# Access Compliance Report

## Public Rights-of-Way

### (Curb Ramps)

Intersection ID: 10100	Main Street: ASHLEY_RD	Cross Street: FREEDOM_DR	Location:	E
ADA ID: 101513260D4C	Ramp Type: Perp	Initial Pass/Fail: Fail	Overall Compliance: No	Severity Score: 22.5
Codes/Mitigation Info/Possible Solution		Field Measurements/Component Compliance

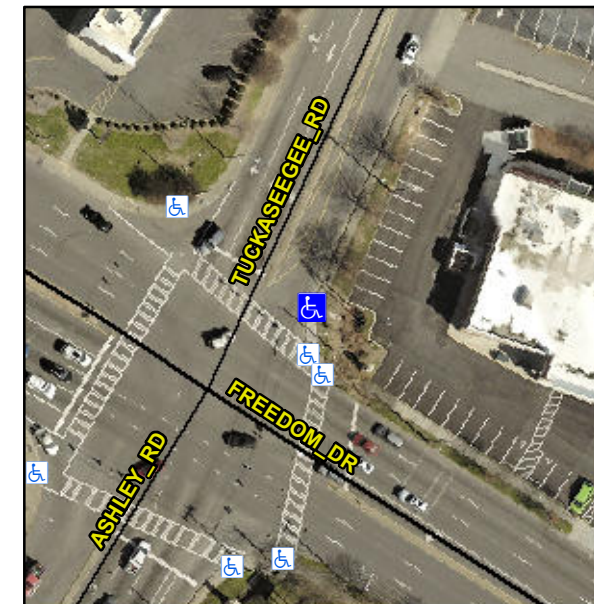
**Not Found, R304.5.1, R304.2.2, R304.5.3**

Compliance	Description	Data	Compliance	Description	Data
N/A	Ramp Length (in)	50.5	No	Ramp Slope (%)	10.5
No	Ramp Width (in)	47.5	No	Ramp XSlope (%)	2.1
N/A	Flare Type LT	N/A	N/A	Flare Type RT	N/A
N/A	Flare Slope LT (%)	N/A	N/A	Flare Slope RT (%)	N/A
N/A	Flare Traversable LT?	N/A	N/A	Flare Traversable RT?	N/A
N/A	Landing Length (in)	N/A	N/A	DWS Provided?	N/A
N/A	Landing Width (in)	N/A	N/A	DWS Contrast?	N/A
N/A	Landing Slope (%)	N/A	N/A	DWS Length (in)	N/A
N/A	Landing X Slope (%)	N/A	N/A	DWS Full Width?	N/A
N/A	Landing Curb? (Y/N)	N/A	N/A	DWS Offset (in)	N/A
N/A	Shared Landing?	N/A			
N/A	Gutter Ponding?	N/A	N/A	Gutter Slope (%)	N/A
N/A	Gutter Lip Ht (in)	N/A	N/A	Gutter X Slope (%)	N/A
N/A	Painted X Walk1?	No	N/A	Painted X Walk2?	N/A
	X Walk 1 Direction	To N		X Walk 2 Direction	N/A
N/A	X Walk 1 Width (in)	N/A	N/A	X Walk 2 Width (in)	N/A
	X Walk 1 Slope (%)	3.6		X Walk 2 Slope (%)	N/A
	X Walk 1 X Slope (%)	1.3		X Walk 2 X Slope (%)	N/A

**Remove & Replace Entire Ramp.**
